# Access Compliance Report

## Public Rights-of-Way

### (Curb Ramps)

Intersection ID: 14726	Main Street: REMOUNT_RD	Cross Street: S_TRYON_ST	Location: S
ADA ID: 2570851B974E	Ramp Type: Perp	Initial Pass/Fail: Fail	Overall Compliance: No
		Severity Score: 12.5

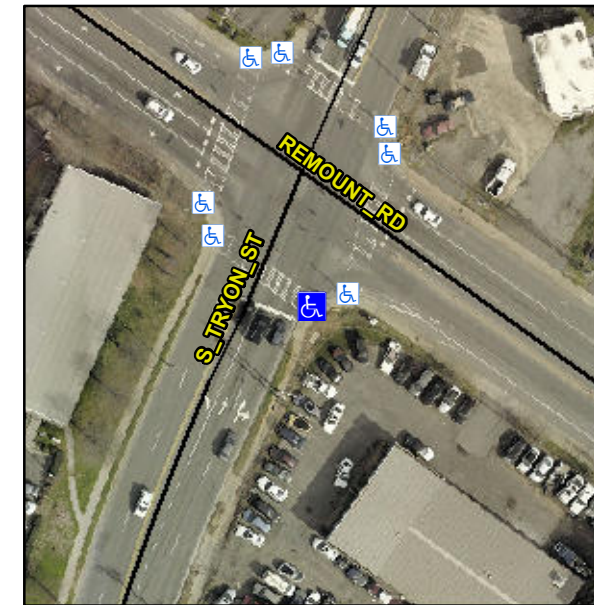
**Not Found, R304.2.2**

Compliance	Description	Data	Compliance	Description	Data
N/A	Ramp Length (in)	72.0	No	Ramp Slope (%)	9.4
Yes	Ramp Width (in)	48.0	Yes	Ramp XSlope (%)	0.7
N/A	Flare Type LT	N/A	N/A	Flare Type RT	N/A
N/A	Flare Slope LT (%)	N/A	N/A	Flare Slope RT (%)	N/A
N/A	Flare Traversable LT?	N/A	N/A	Flare Traversable RT?	N/A
N/A	Landing Length (in)	N/A	N/A	DWS Provided?	N/A
N/A	Landing Width (in)	N/A	N/A	DWS Contrast?	N/A
N/A	Landing Slope (%)	N/A	N/A	DWS Length (in)	N/A
N/A	Landing X Slope (%)	N/A	N/A	DWS Full Width?	N/A
N/A	Landing Curb? (Y/N)	N/A	N/A	DWS Offset (in)	N/A
N/A	Shared Landing?	N/A			
N/A	Gutter Ponding?	N/A	N/A	Gutter Slope (%)	N/A
N/A	Gutter Lip Ht (in)	N/A	N/A	Gutter X Slope (%)	N/A
N/A	Painted X Walk1?	Yes	N/A	Painted X Walk2?	N/A
	X Walk 1 Direction	To NW		X Walk 2 Direction	N/A
N/A	X Walk 1 Width (in)	110.0	N/A	X Walk 2 Width (in)	N/A
	X Walk 1 Slope (%)	0.9		X Walk 2 Slope (%)	N/A
	X Walk 1 X Slope (%)	0.1		X Walk 2 X Slope (%)	N/A

**Remove & Replace Entire Ramp.**
